**DEPARTMENT OF THE AIR FORCE
AIR FORCE CIVIL ENGINEER CENTER**

**SUBJECT: Final Revised Proposed Plan, Operable Unit 1, Site CG070, former George
Air Force Base (AFB), California**

This Final Revised Proposed Plan has been prepared in response to comments on the Draft Final Revised Proposed Plan from the RWQCB, Lahontan Region, and the U.S. EPA received on January 31, 2014 and February 4, 2014, respectively. See Response to Comments Table within the final document.

Revised Proposed Plan Operable Unit 1, Site CG070 Former George Air Force Base

Figure 12
TCE Plume Maps for Upper Aquifers

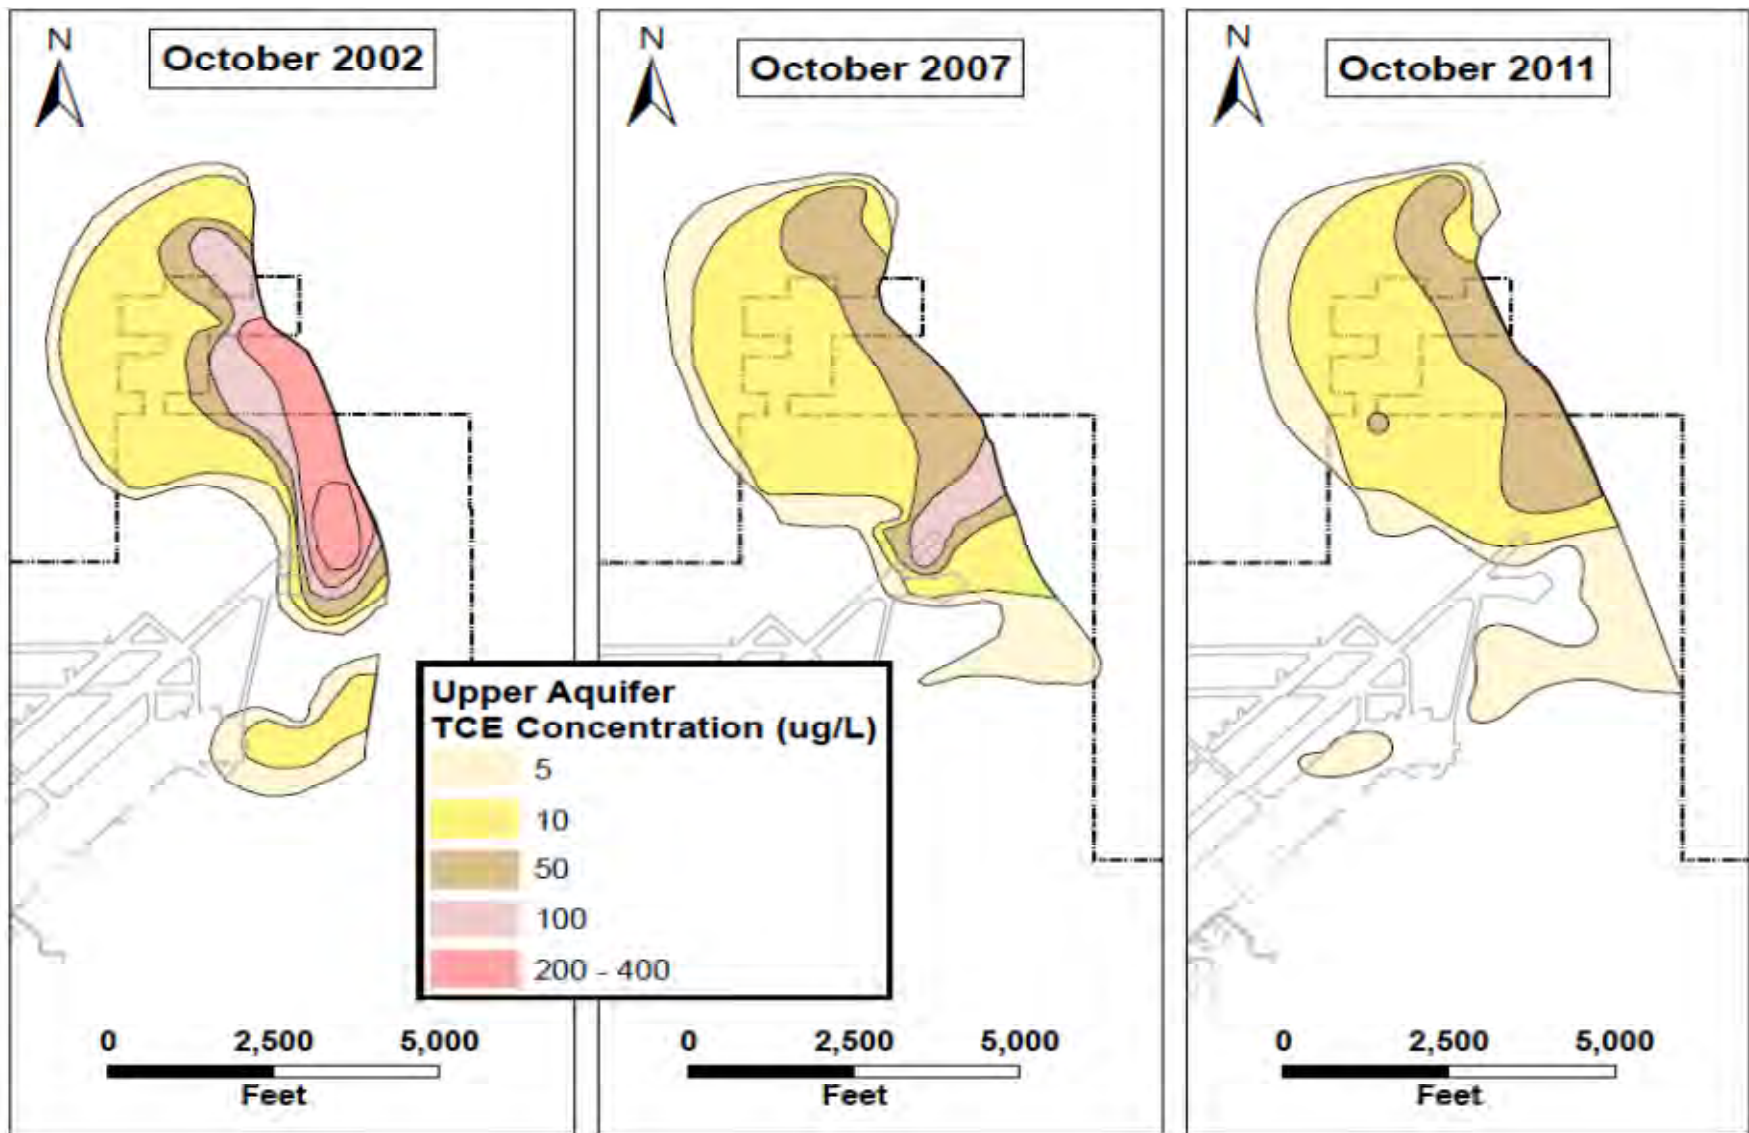
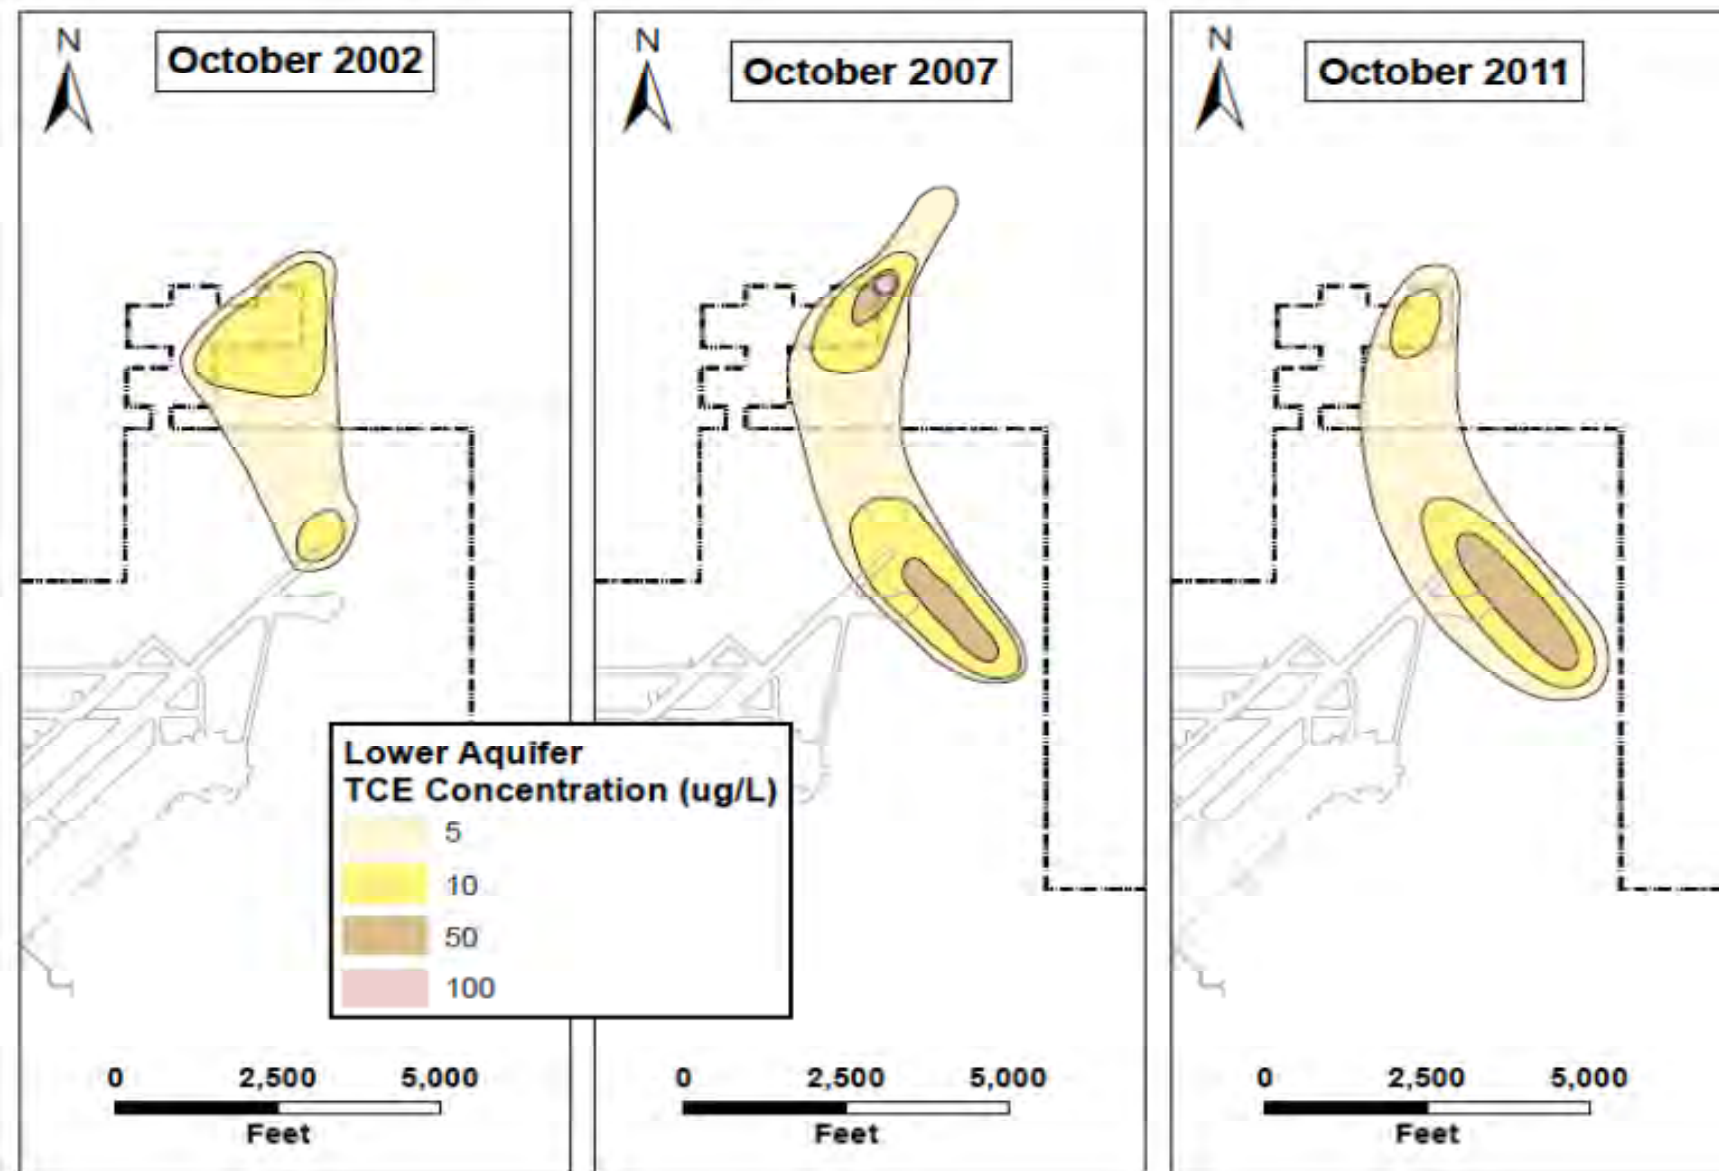
22.	Figure 5, TCE Plume Maps for Upper and Lower Aquifers, Page 10	The size and resolution of this figure make it unreadable. Three or four figures for each aquifer should suffice to demonstrate plume characteristics, and the figures should be enlarged. Please revise this figure to ensure that key elements are legible.	The figure referenced in the Draft Final OU 1 Proposed Plan is simplified and split in two (Figures 12 and 13) for ease of understanding.

Figure 14
Water Supply Wells Downgradient from the Lower Aquifer Plume

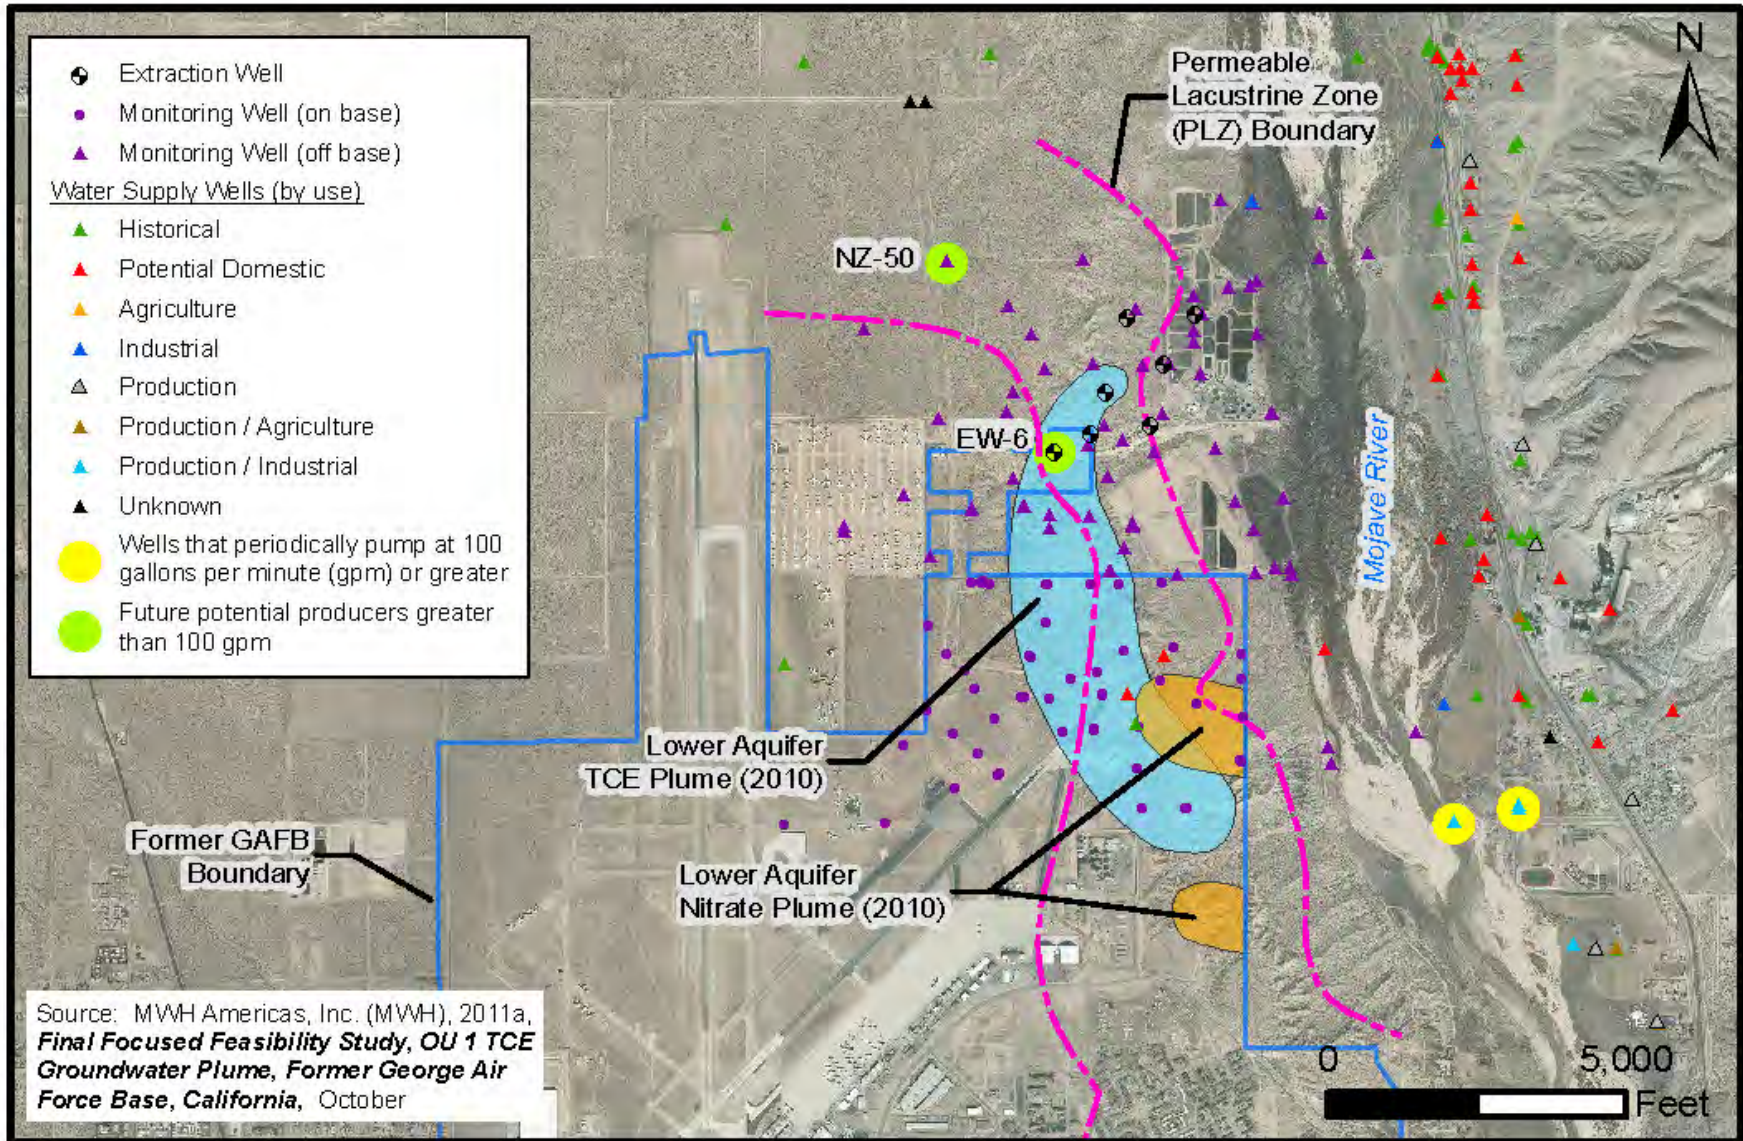
Item	Section	Pg	Comments	Responses
11	Figure 14, Water Supply Wells Downgradient from the Lower Aquifer Plume	25	When printed out on an 8 x 11 inch sheet of paper, the supply wells are difficult to identify and impossible to associated with the TCE and nitrate plumes. Please embolden the supply wells and overlay the plumes so that the community can see what this figure is attempting to depict.	The suggested changes have been made to the figure.
12	Figure 14, Water Supply Wells Downgradient from the Lower Aquifer Plume	25	The significance of Figure 14 is not discussed within the text of the Draft Final Revised PP (the only reference is for additional delineation in the vicinity of EW-6). Since this figures shows water supply wells, it should be discussed in the text of the PP. Please revise the PP to discuss Figure 14 in the text of the Draft Final Revised PP.	The following has been added to the end of the section: <i>"The relationships of the TCE plumes in the aquifers to the potential and actual water supply wells are shown on Figure 14."</i>
